## **CCNPP3COLA PEmails**

DRAFT  
Request for Additional Information No. 192 Revision 2

Calvert Cliffs Unit 3  
UniStar  
Docket No. 52-016  
SRP Section: 02.03.02 - Local Meteorology  
Application Section: 2.3.2  
RSCA

Seasonal wind speed and direction comparison between the CCNPP site and Patuxent Naval Air Station (NAS).

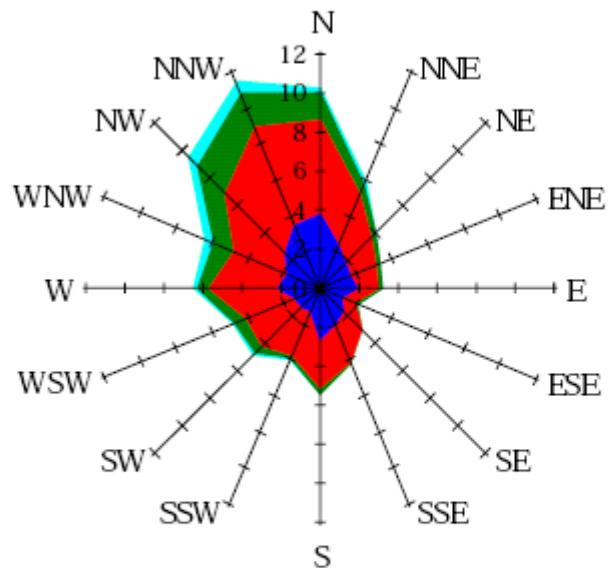
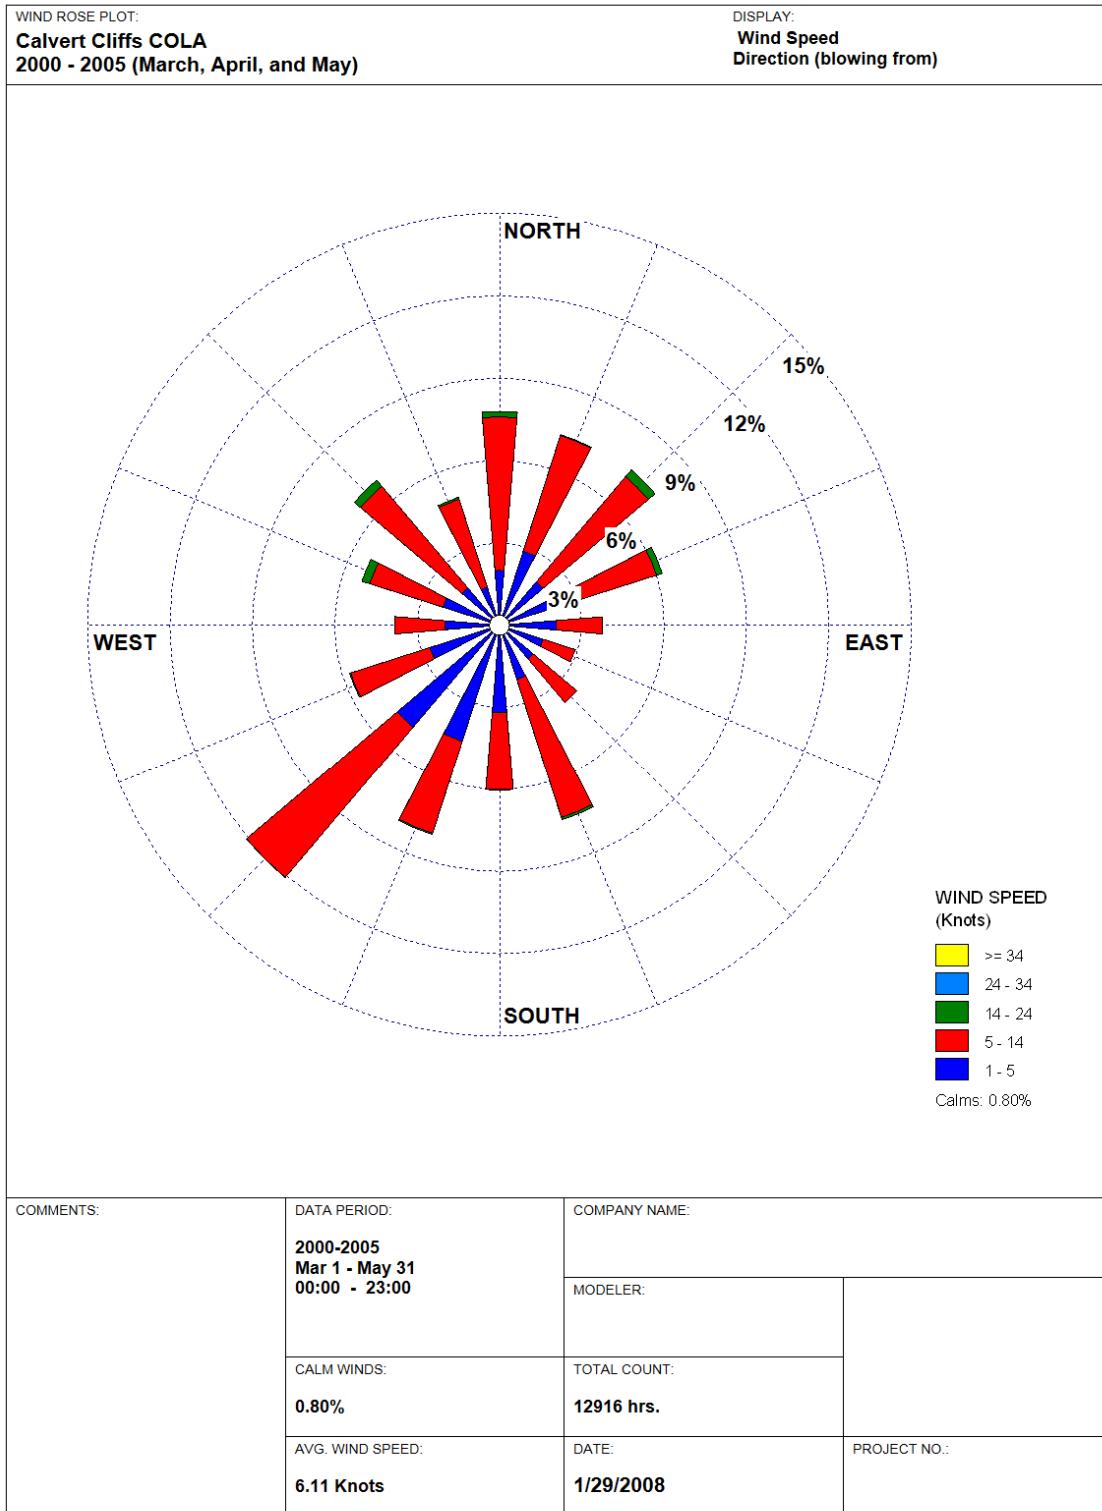
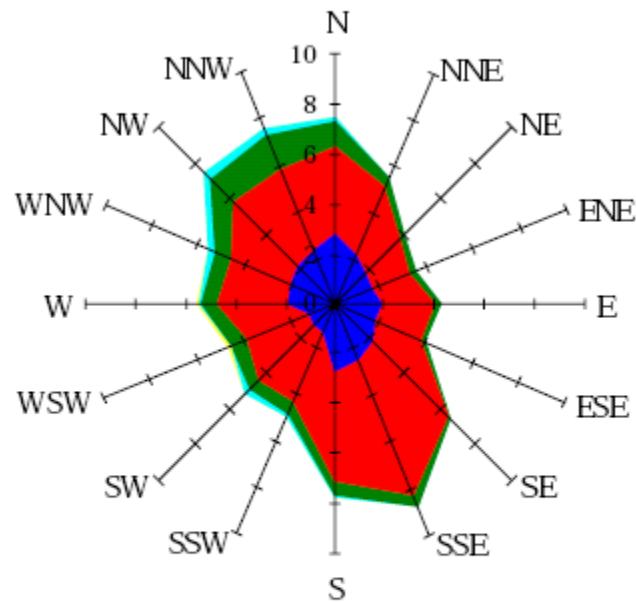
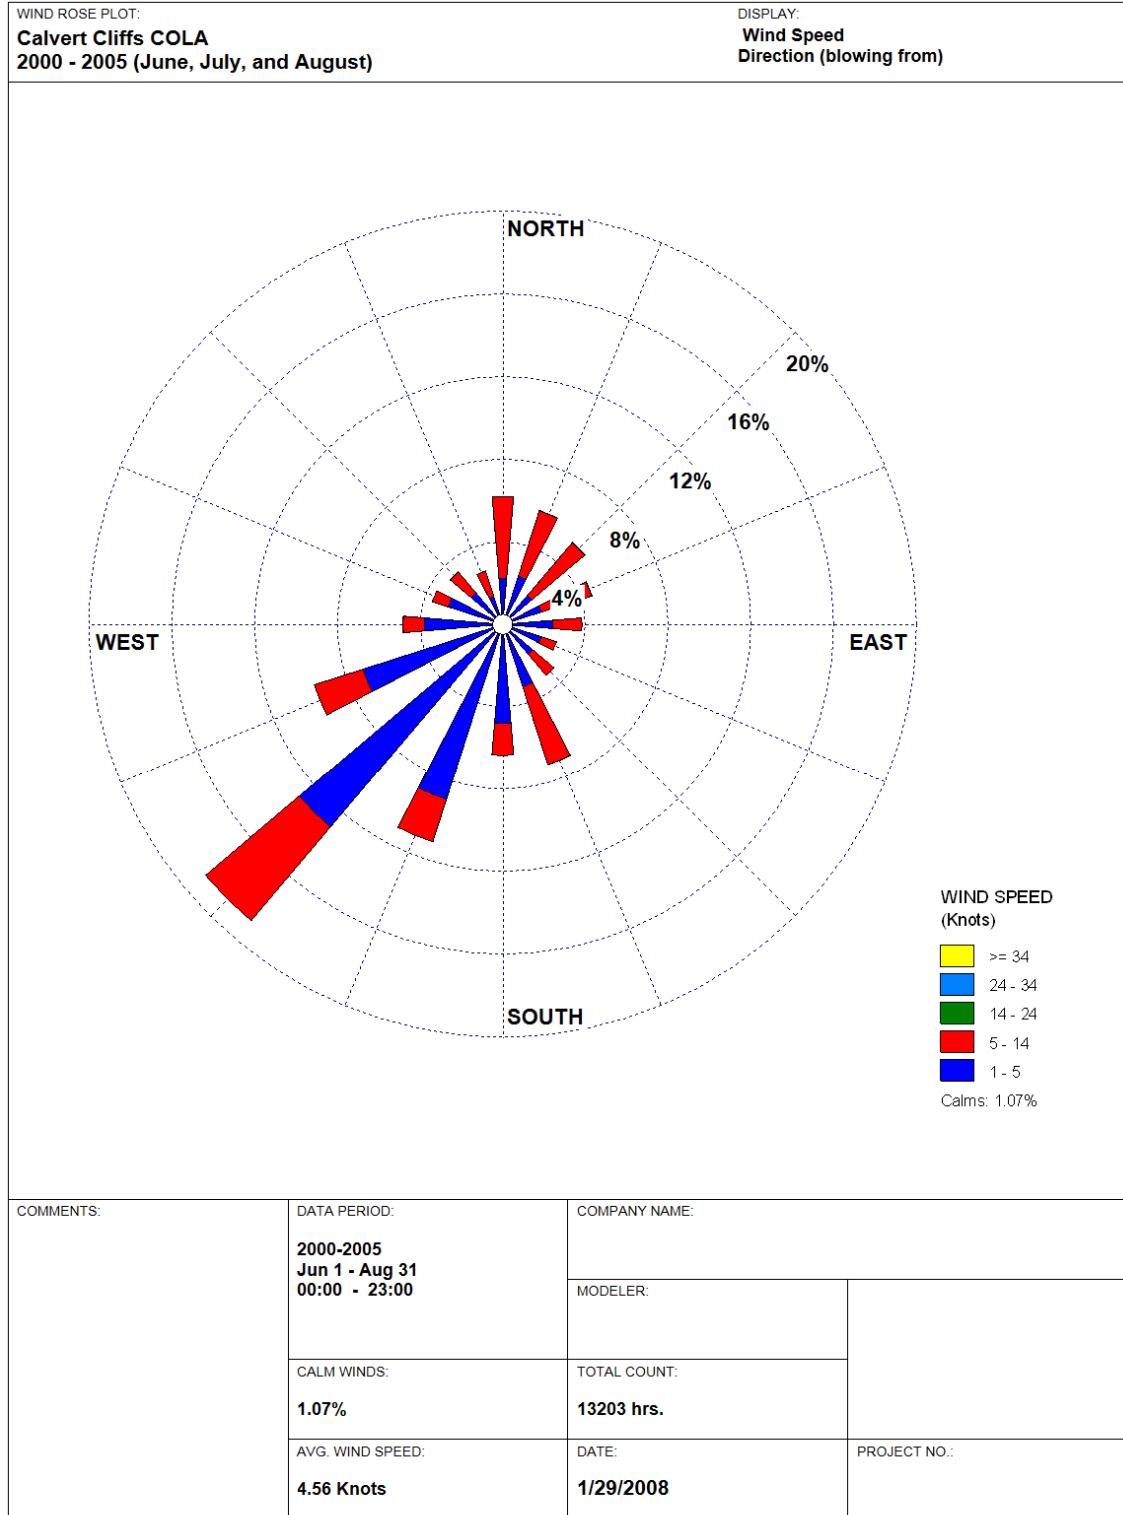
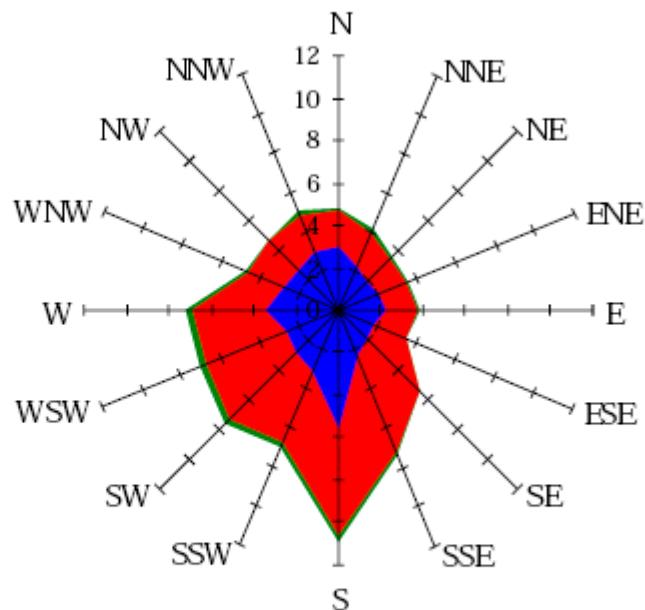
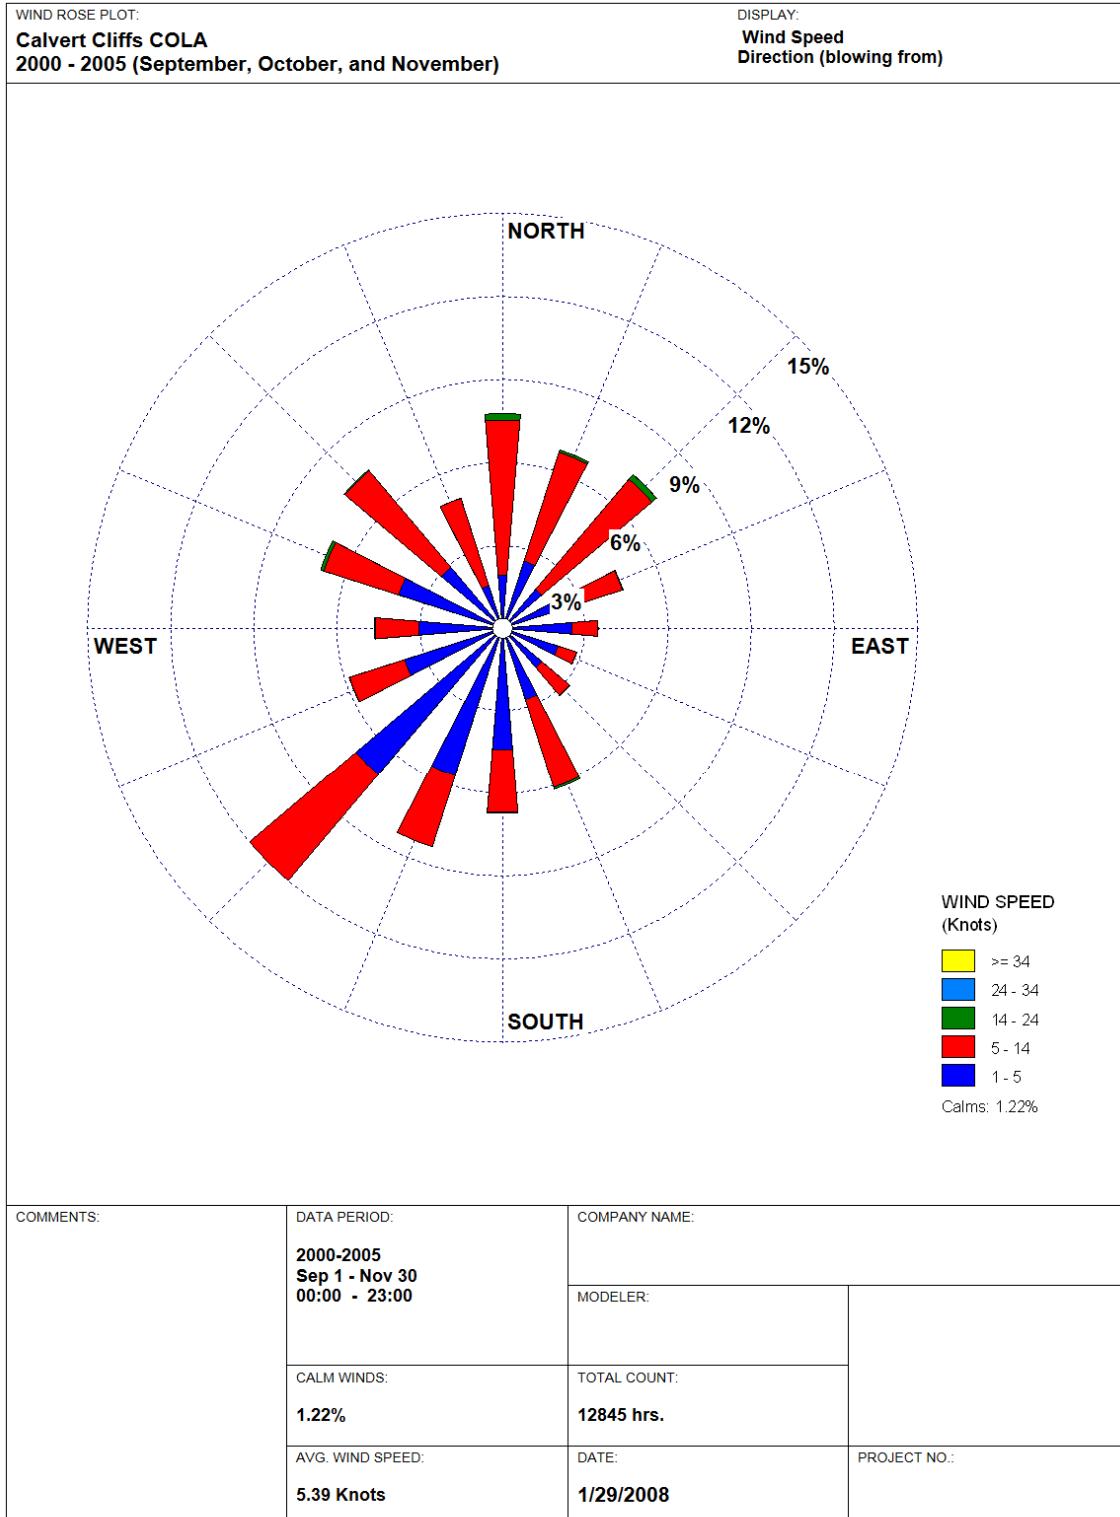
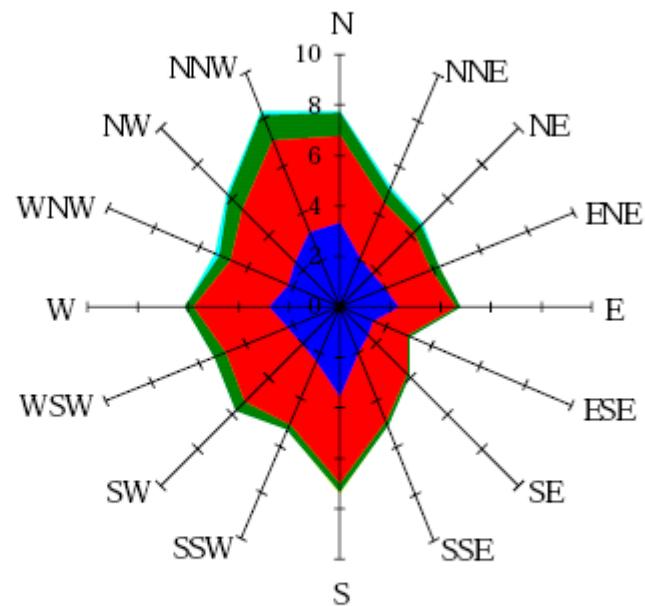
Seasonal comparisons of wind direction and frequency from Patuxent Naval Air Station (NAS) with onsite data from the proposed CCNPP site show several differences, especially the percentage of calm conditions. Please provide a discussion regarding the significance of the seasonal wind speed and direction differences between the two locations and the representativeness of the onsite wind speed and direction measurements. Seasonal wind roses for both Patuxent NAS and the CCNPP site are provided in Attachment 1.
